UNITED STATES PATENT AND TRADEMARK OFFICE

APPLICATION NO.	FILING DATE	FIRST NAMED INVENTOR	ATTORNEY DOCKET NO.	CONFIRMATION NO.
10/670,036	09/23/2003	Michael D. Flasz	00580-0190US	5048
32116	7590	08/10/2005	EXAMINER	
WOOD, PHILLIPS, KATZ, CLARK & MORTIMER 500 W. MADISON STREET SUITE 3800 CHICAGO, IL 60661			ENGLUND, TERRY LEE	
			ART UNIT	PAPER NUMBER
			2816

Office Action Summary

DETAILED ACTION

FIG. 1

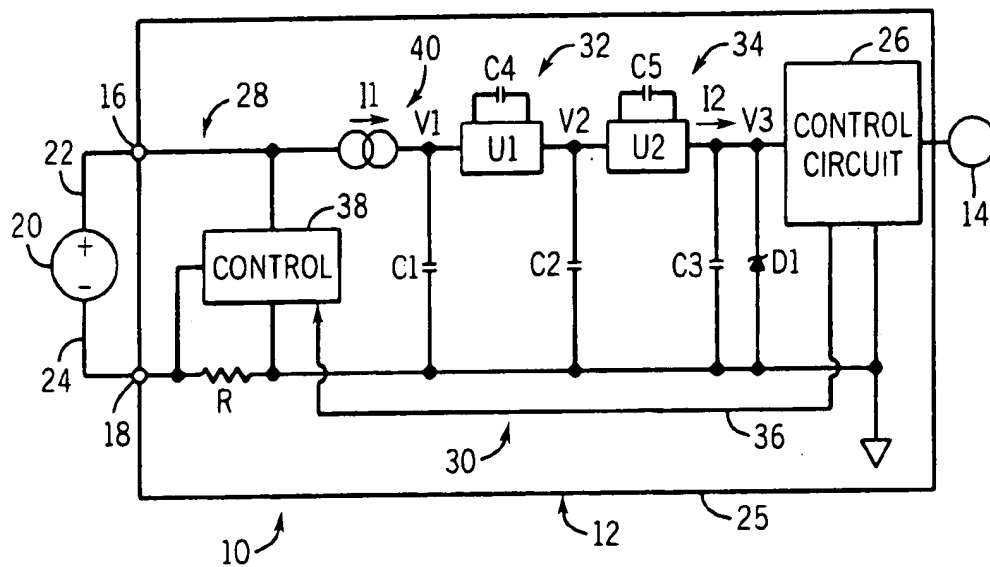
Since page 4 of the amendment implies additional information can be provided, the following is requested: At least one specific example (e.g. circuit details or structure) of each of the following: control 38, control circuit 26, both shown in the applicant's Fig. 1. With those examples, the examiner may be able to more accurately determine what, and how, control within the applicant's circuit is actually performed. Without this type of information, it is not clear how all the claimed limitations are met.

The disclosure remains objected to because of the following informalities: Clarification is requested with respect to how control circuit 26 "of any known design" (see page 7, lines 4-6) and control block 38 (see page 7, lines 12-14), can actually perform their function. Using the

applicant's own Fig. 1 as a reference, it is understood that control circuit 26 is coupled between voltage V3 and ground, provides control signal 36, and has some type of connection to primary element 14. However, it is not understood what this control circuit can be, and how control signal 36 and the connection to 14 relate to one another. For example, a simple two resistor voltage divider can provide a control signal from between the two resistors, wherein the connection to 14 could possibly be to either V3, or control signal 36. Control 38 is known to be coupled between power supply 22 (at node 16) and ground, with another connection to node 18, and an input receiving control signal 36. It is believed control 38 could be a comparator coupled between 16 and ground for power, receiving the potential at node 18 as a reference signal, and receiving control signal 36 as the variable/comparison signal. However, it is not understood how control 38 actually controls the current through the loop. Does control 38 have an output the controls current source 40, and/or somehow controls the switching within U1 and U2? As presently shown and described, it is understood control 38 is coupled in parallel with respect to power supply 20 and sense resistor R, wherein current source 40, charge pump circuits U1 and U2, and control circuit 26 are also coupled in parallel with 20 and R. Therefore, from the figure, and lack of specific details within the description, it is not understood how loop current I1 would be affected by control 38. Appropriate corrections and/or clarifications required.

Claims 1-20 remain rejected under 35 U.S.C. 112, first paragraph, as based on a disclosure which is not enabling. How the loop current is actually controlled is considered by this examiner to be critical or essential to the practice of the invention. Therefore, this current control limitation included in the claim(s) is not enabled by the disclosure. See *In re Mayhew*, 527 F.2d 1229, 188 USPQ 356 (CCPA 1976). Although control block 38, shown in Fig. 1, allegedly controls the loop current, the description and the circuit shown in Fig. 1 do not indicate how that is actually performed. As described above with respect to the disclosure and Fig. 1, control 38 does not appear to actually affect the loop's current since control 38 is simply shown connected between node 16 and ground, and in parallel with 20/R as well as with 40/U1/U2/26. This type of configuration does not provide sufficient information to how the loop current will be controlled. For example, does control 38 control only current source 40, one or both of the charge pump circuits U1 and U1, or some combination of these elements?
